**San Diego Gas & Electric Company (SDG&E) and Southern California Gas Company (SoCalGas) Responses  
A.15-09-013 Pipeline Safety & Reliability Project (PSRP or Proposed Project)  
California Public Utilities Commission (CPUC) Data Request No. 04 – September 12, 2017**

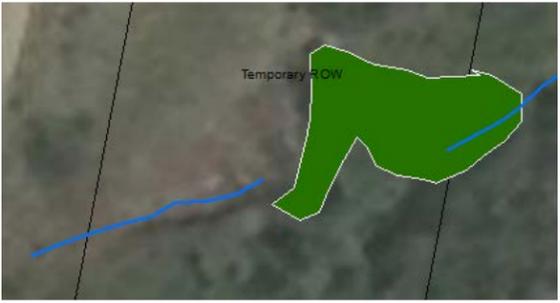
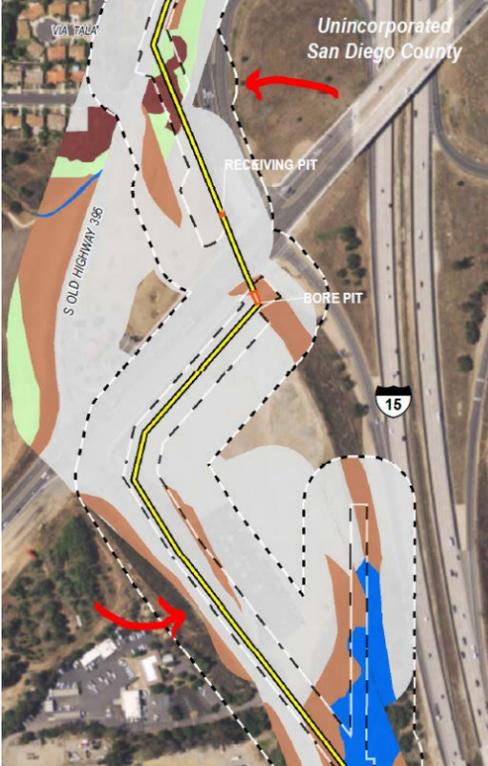
4.4-1 Follow-up	Biological Resources	Wetlands Delineation Report submitted 2/10/17	<p><b>Please provide GIS data for formal wetland delineation.</b> The GIS data provided in October of 2015 does not match the figures attached to the 2017 Wetland Delineation Report. See screenshots below. The first image represents the wetland data that was submitted 10-1-2015, in the "Wetlands_Waters.shp" file. The second image is from the February 2017 Wetland Delineation Report.</p> 		<p>The data provided in October 2015 was associated with the Preliminary Wetland and Waters Assessment dated September 2015. At that time, potential wetlands were mapped, but not delineated. The mapping was primarily based on wetland indicators, such as hydrophytic vegetation, but did not look at the soils or hydrology. The data in the Wetland Delineation Report dated February 2017 is based on a wetland delineation and would be considered more accurate than the preliminary assessment.</p> <p>Typically, the preliminary assessment and the wetland delineation mapping are very close. In this case, it is not because the wetland is located in a highly-disturbed area. The ROW follows a fire break to take advantage of previously disturbed land. During the 2015 field surveys, the fire break was recently mowed, so some of the wetland indicators were likely not present and were therefore not mapped. During the wetland delineation, soils, hydrology, and plants were assessed and the boundaries of the wetland were expanded.</p>
